UNITED STATES PATENT AND TRADEMARK OFFICE

| APPLICATION NO. | FILING DATE | FIRST NAMED INVENTOR | ATTORNEY DOCKET NO. | CONFIRMATION NO. |
|-----------------|-------------|----------------------|---------------------|------------------|
| 10/648,305 | 08/27/2003 | Klaus Junker | 1415 US | 3682 |

| Office Action Summary | Application No. 10/648,305 | Applicant(s) JUNKER ET AL. | |

DETAILED ACTION

Figure 3

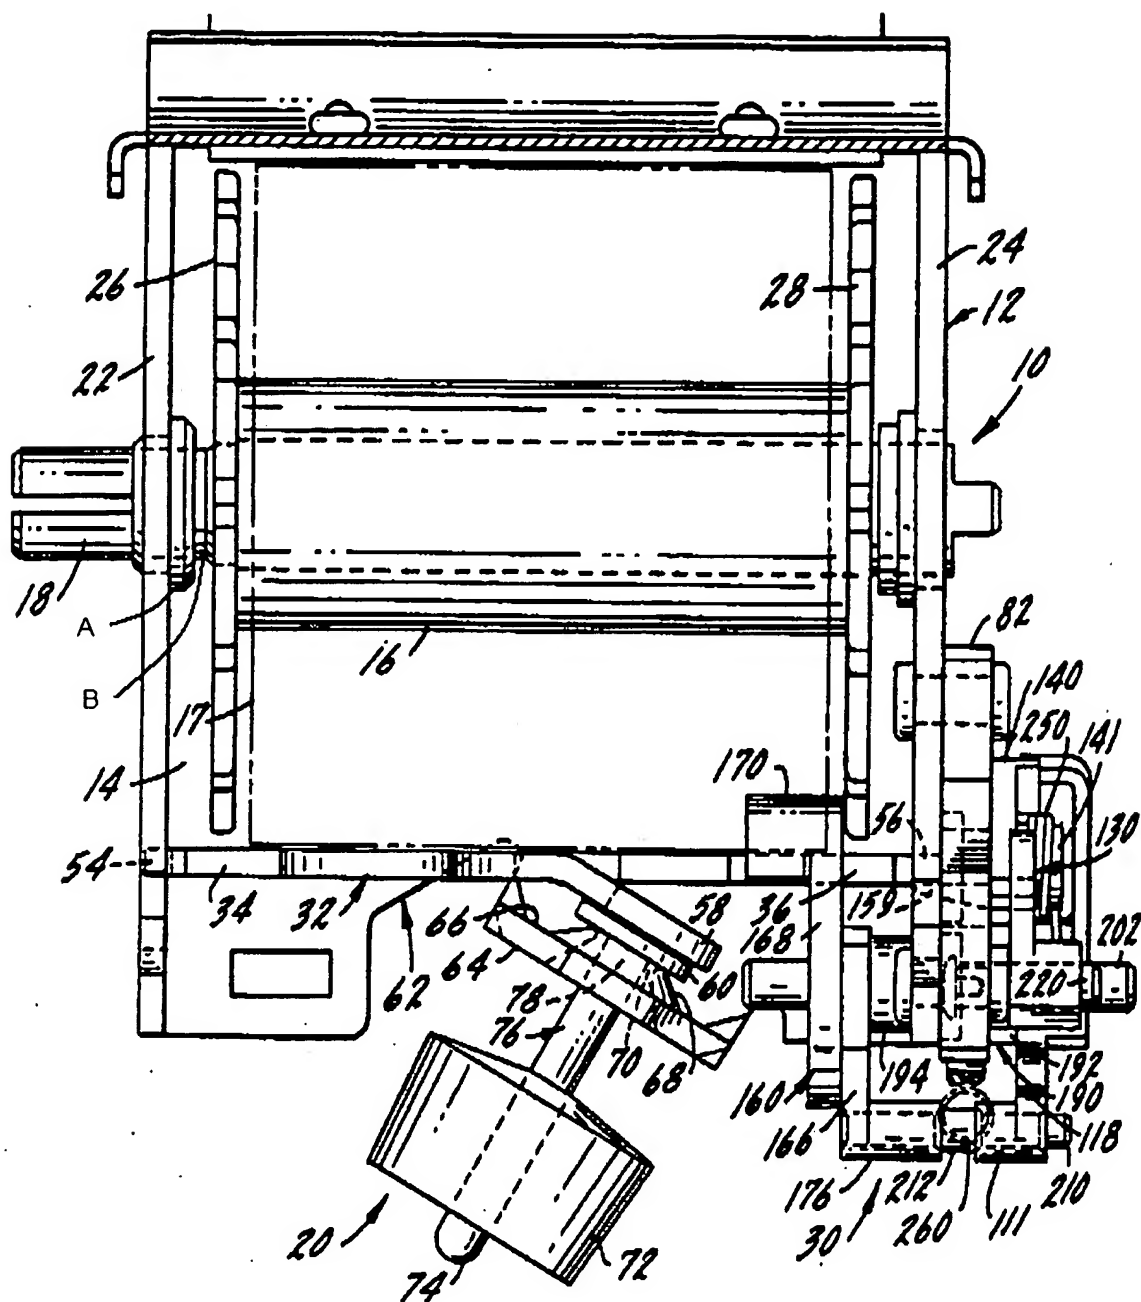
- torsion bar (16)
 - gear (26) integral therewith,
 - flange (see figure 3 below;(A)) integral with the torsion bar located at an end of the torsion bar with a circumferential groove (B) having generally radially inclined side boundary surfaces (see side surfaces of groove in figure 3 below) in the bar being adjacent to and disposed between the flange and the gear, wherein the circumferential groove extends into the torsion bar more deeply in a radial direction than the trough between the gear teeth of the adjacent gear,

- the circumferential groove having one side boundary surface on the flange and the opposite side boundary surface adjacent to and radially deeper than the trough between the gear teeth of said gear.
